# National Committee on Uniform Traffic Control Devices

## National Committee on Uniform Traffic Control Devices (NCUTCD) Recommended Changes to Proposed Text for 11<sup>th</sup> Edition of the MUTCD Docket Number: FHWA-2020-0001

7 **NPA MUTCD Section Number:** Sections 3C.01-3C.12

**Figure 3C-1. Examples of Crosswalk Markings**

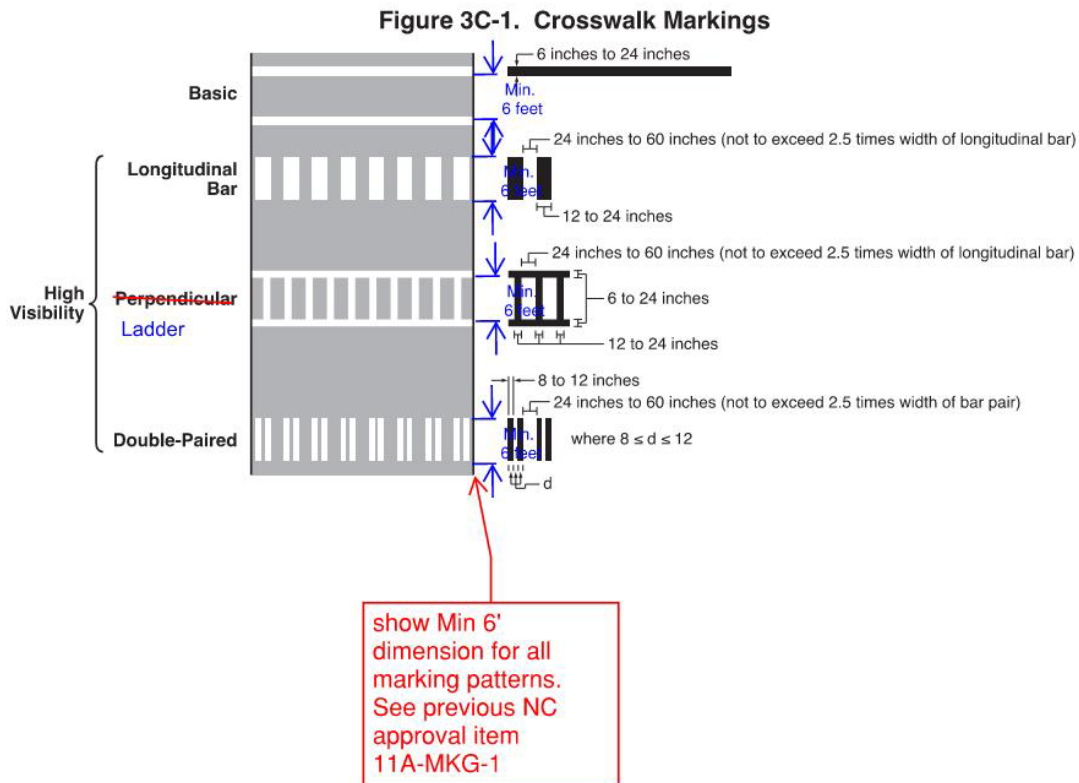
166 **Figure 3C-1 Comments:** NCUTCD generally agrees with Figure 3C-1, but recommends  
167 revising to show a minimum 6 foot crosswalk width in accordance with NCUTCD  
168 recommendation 11A-MRK-01. NCUTCD also recommends renaming “perpendicular”  
169 crosswalks as “ladder” crosswalks, as this is the more commonly-used term for this crosswalk  
170 marking pattern.

Figure 3C-2. Example of Crosswalk Markings  
for an Exclusive Pedestrian Phase  
that Permits Diagonal Crossing

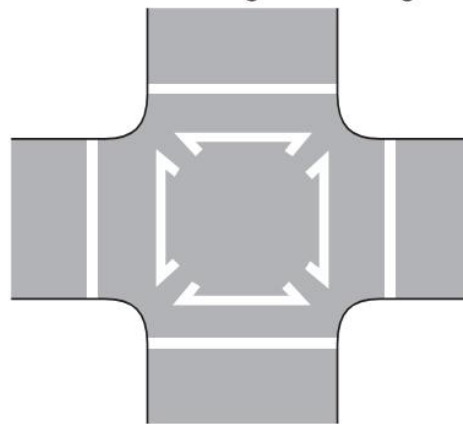
313 **Figure 3C-2 Comments:** NCUTCD agrees with Figure 3C-2 as presented in the NPA.
